**RECONSTRUCTION OF ENCINA AVENUE
FROM MIDDLEFIELD ROAD TO END**

**COUNTY PROJECT NO. RW703
PROJECT FILE NO. E5044000**

ADDENDUM NO. 1

D DRAINAGE APRON LEFT DETAIL
17 AT INFILTRATION GALLERY 2
 NOT TO SCALE

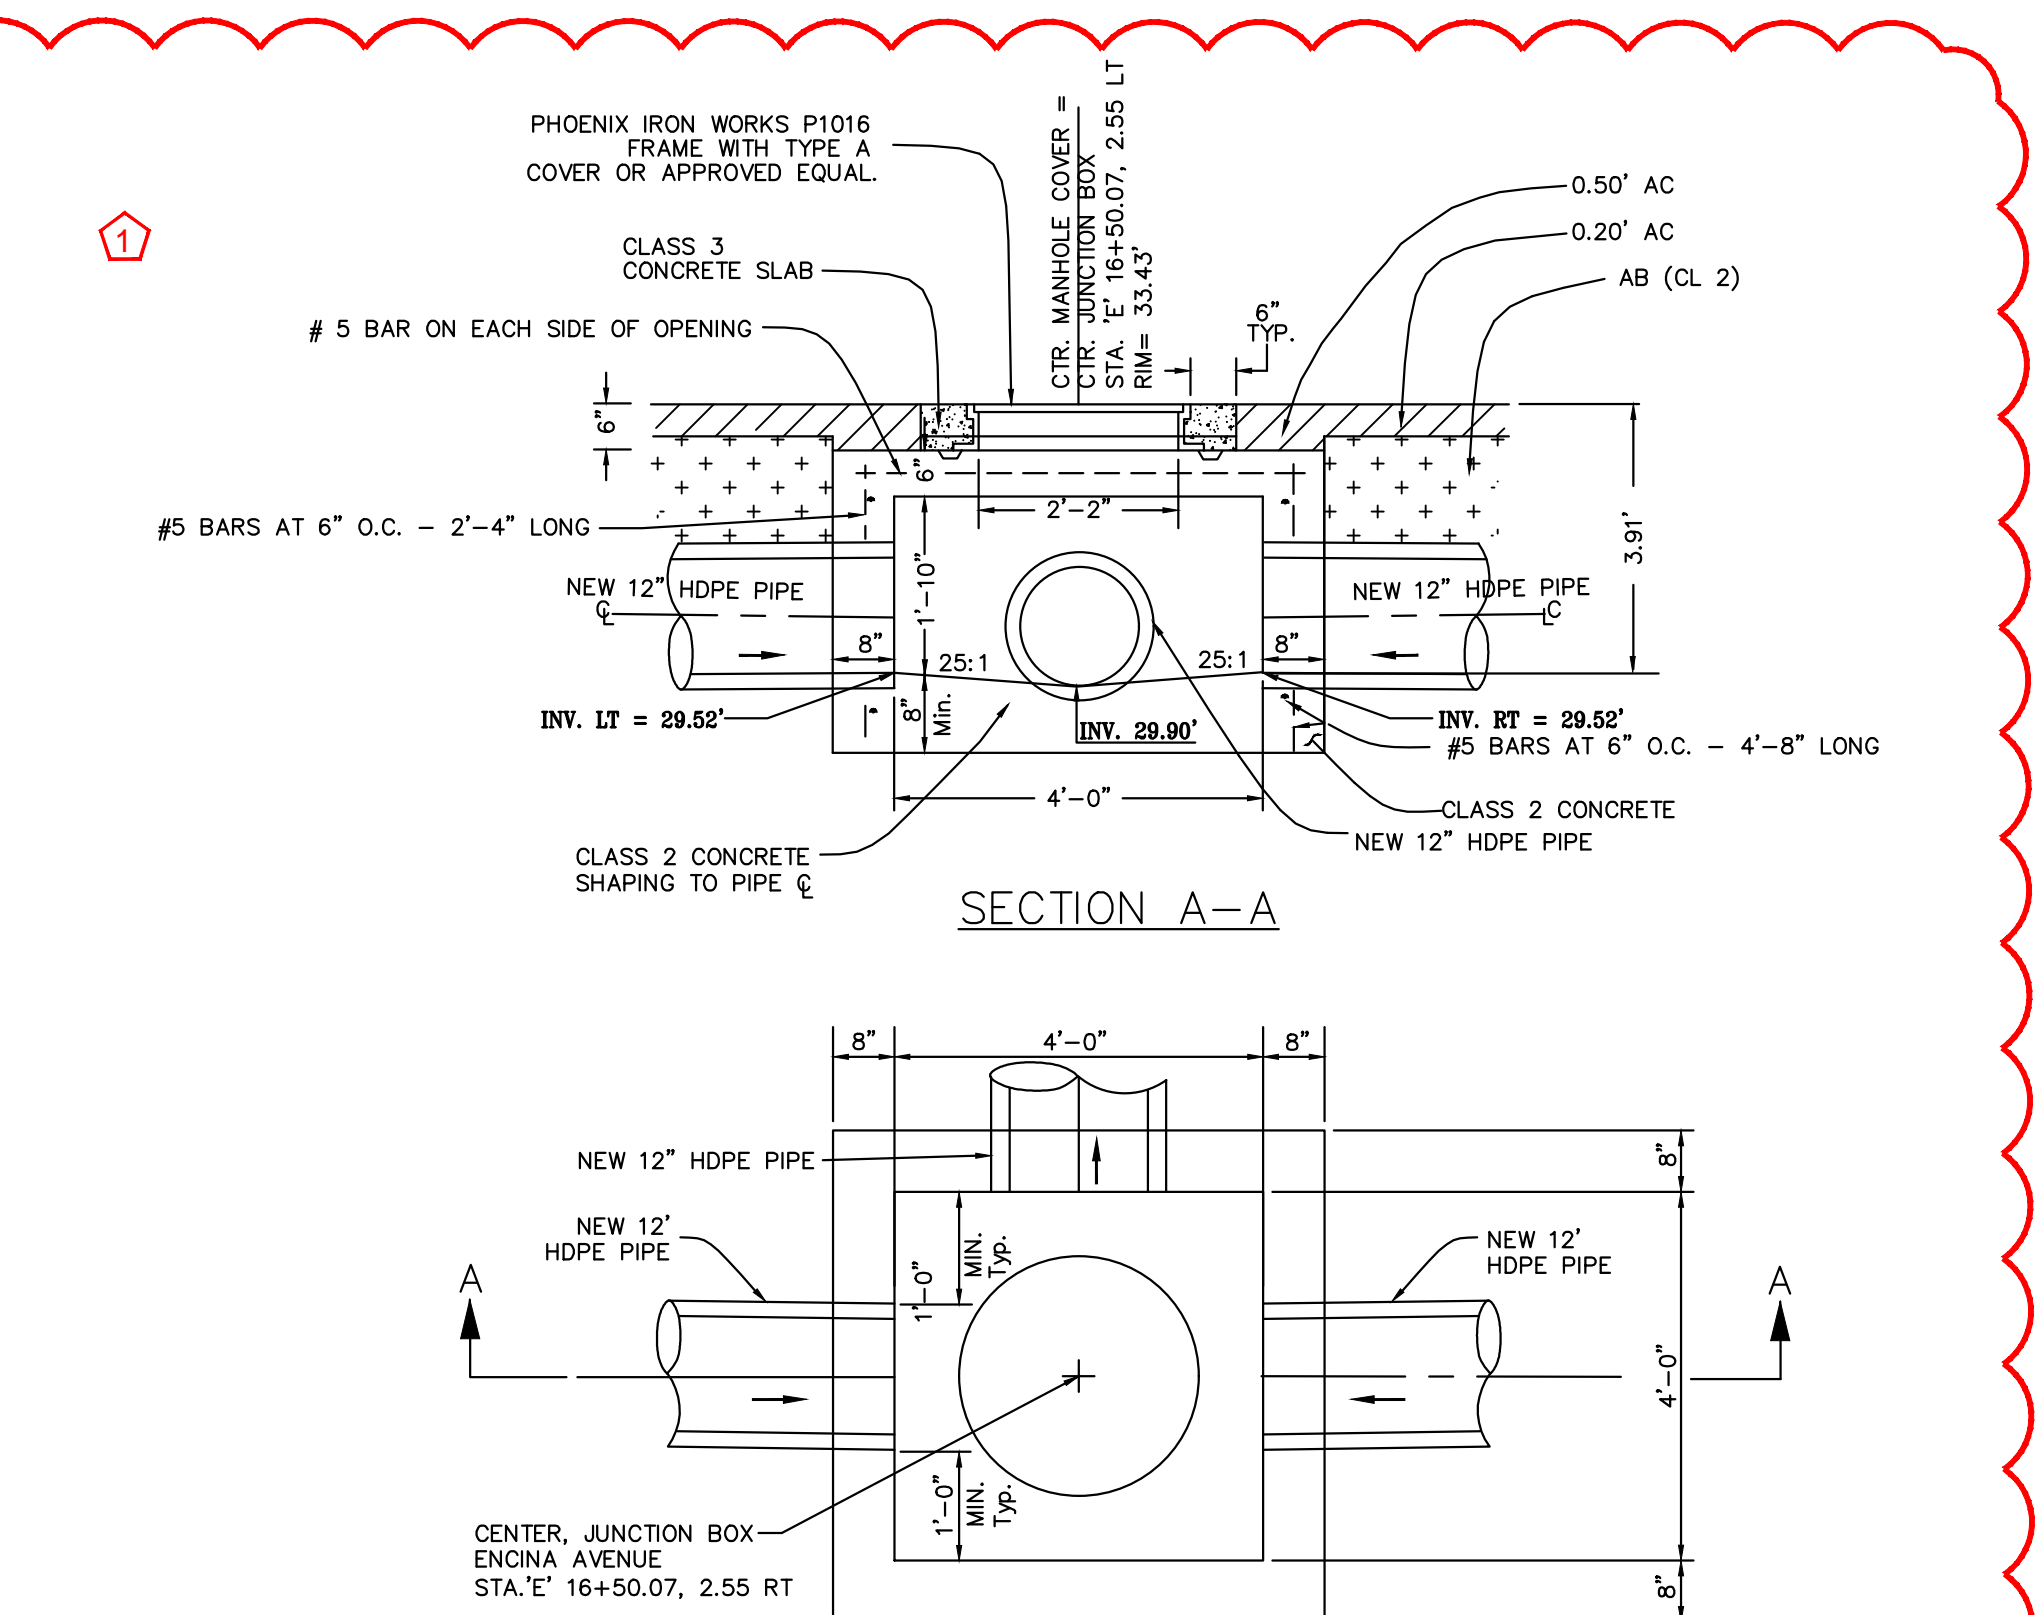
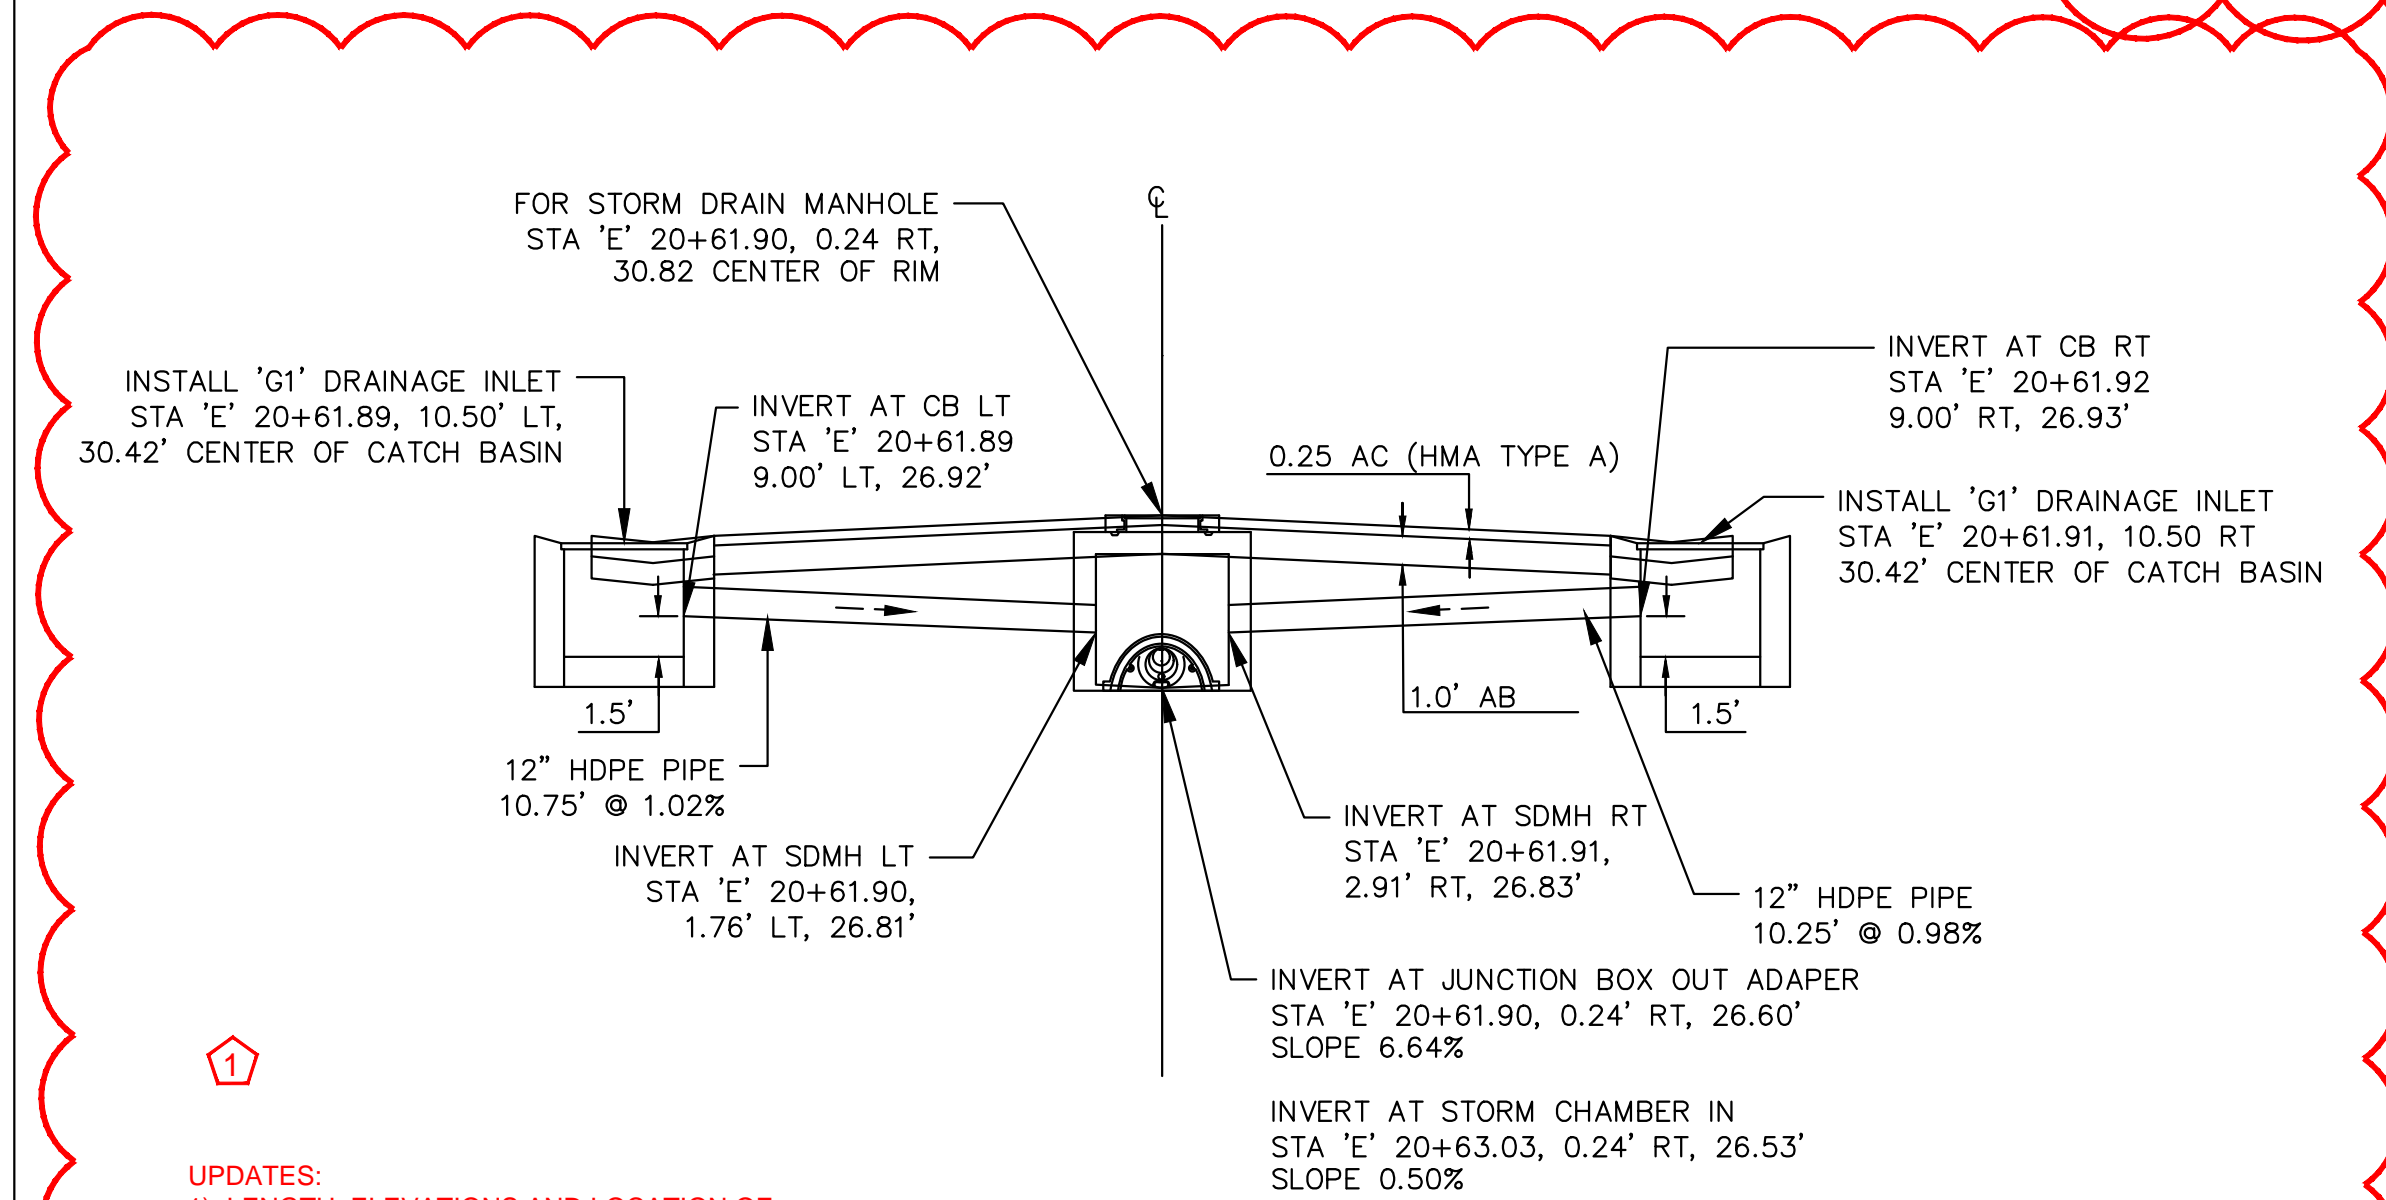
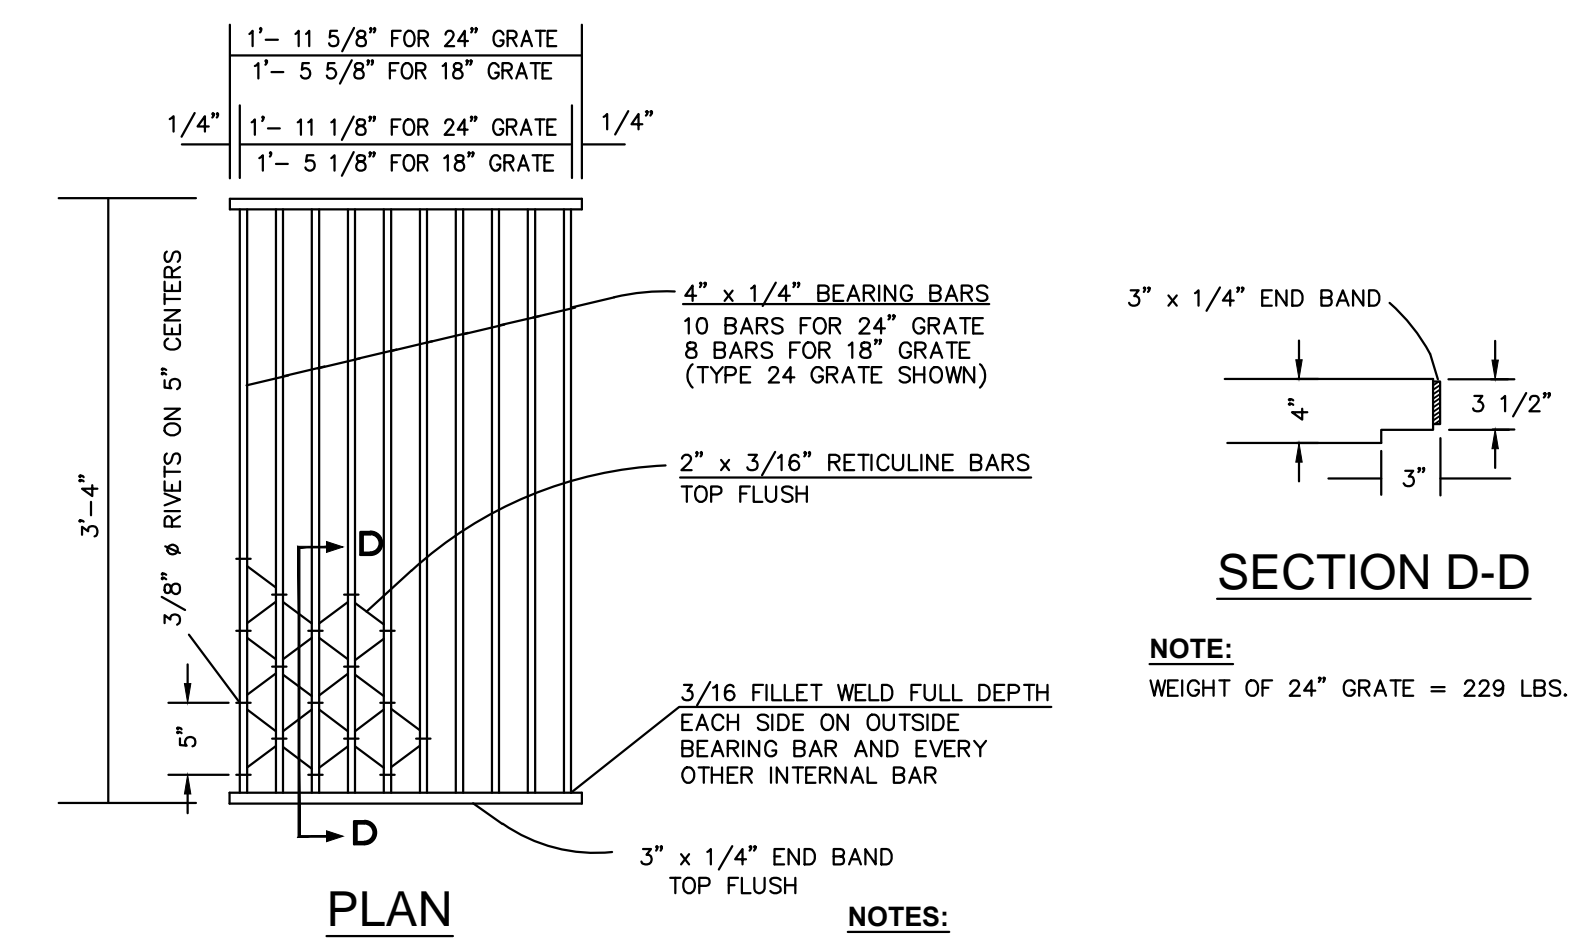
UPDATES:
 1) LENGTH, ELEVATIONS AND LOCATION OF INFILTRATION GALLERY, CATCH BASINS, STORM DRAIN MANHOLES AND STORM CHAMBERS

UPDATES:
 1) LENGTH, ELEVATIONS AND LOCATION OF INFILTRATION GALLERY, CATCH BASINS, STORM DRAIN MANHOLES AND STORM CHAMBERS

UPDATES:
 1) LENGTH, ELEVATIONS AND LOCATION OF INFILTRATION GALLERY, CATCH BASINS, STORM DRAIN MANHOLES AND STORM CHAMBERS

UPDATES:
 1) LENGTH, ELEVATIONS AND LOCATION OF INFILTRATION GALLERY, CATCH BASINS, STORM DRAIN MANHOLES AND STORM CHAMBERS

UPDATES:
 1) LENGTH, ELEVATIONS AND LOCATION OF INFILTRATION GALLERY, CATCH BASINS, STORM DRAIN MANHOLES AND STORM CHAMBERS

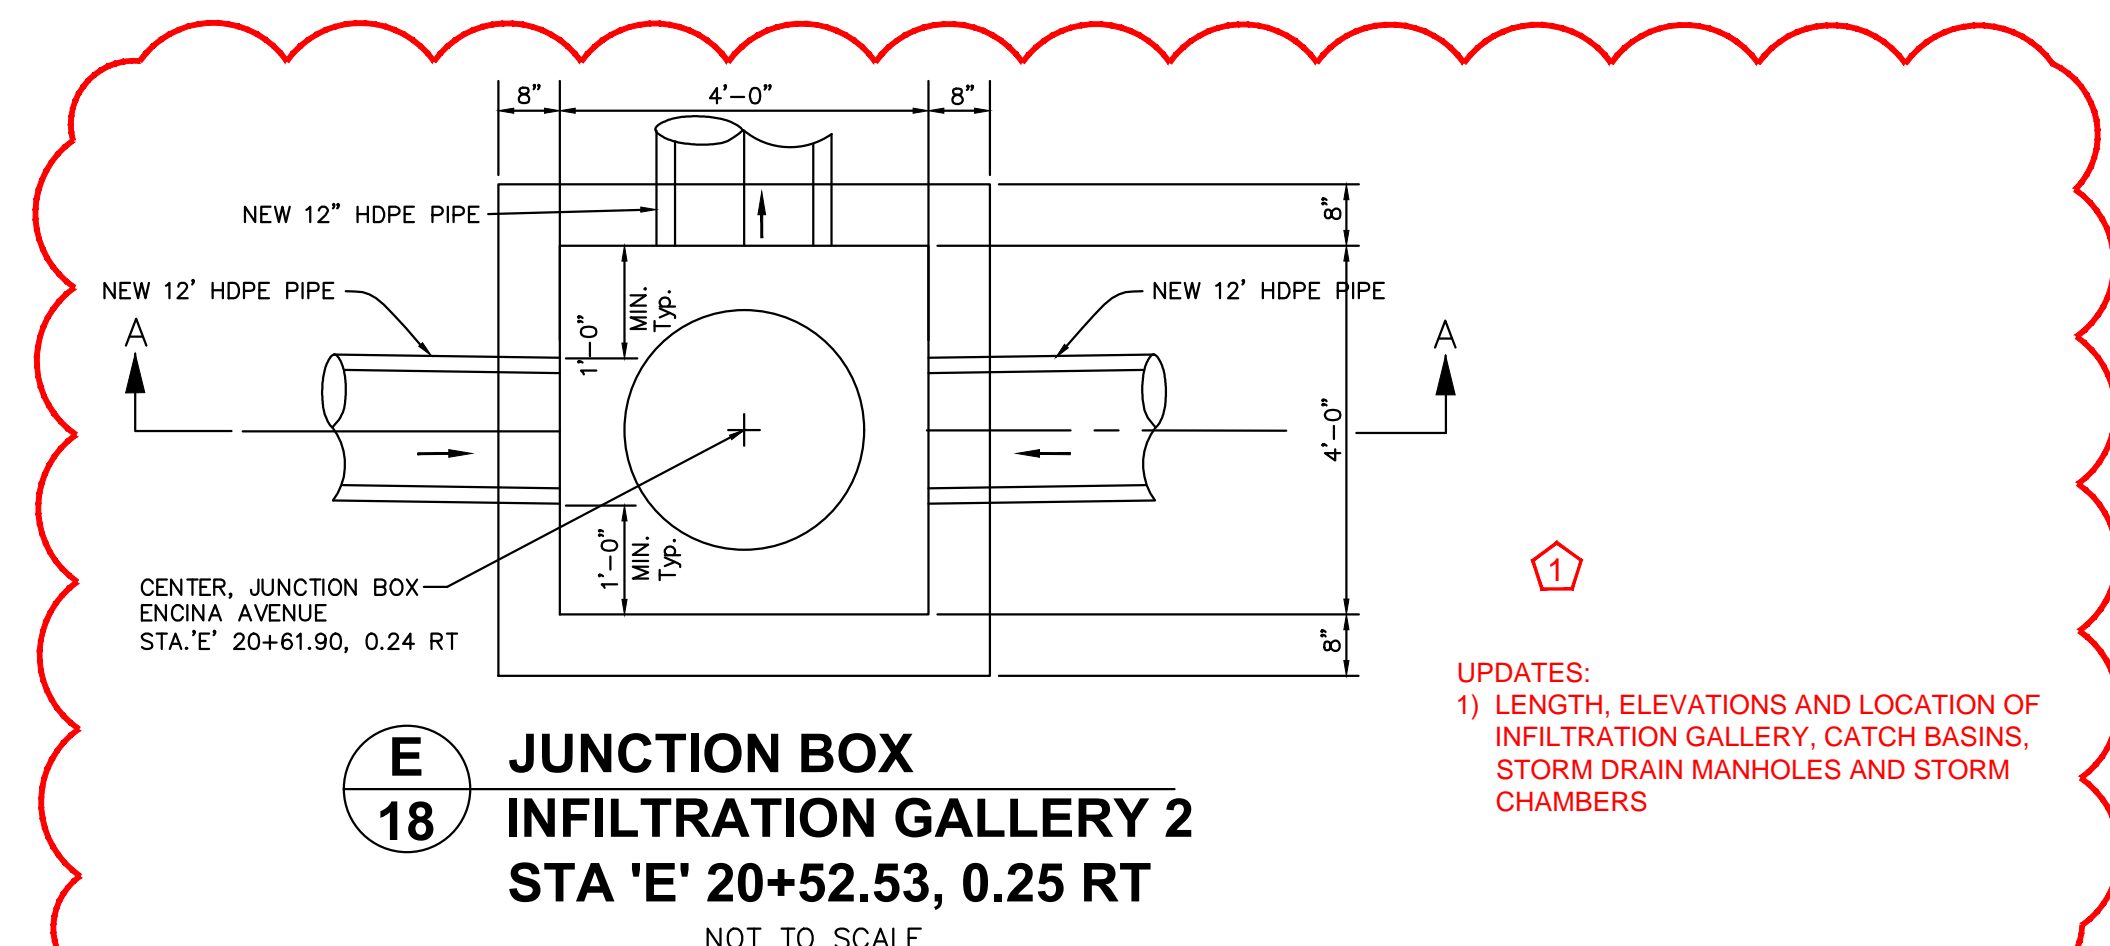
UPDATES:
 1) LENGTH, ELEVATIONS AND LOCATION OF INFILTRATION GALLERY, CATCH BASINS, STORM DRAIN MANHOLES AND STORM CHAMBERS
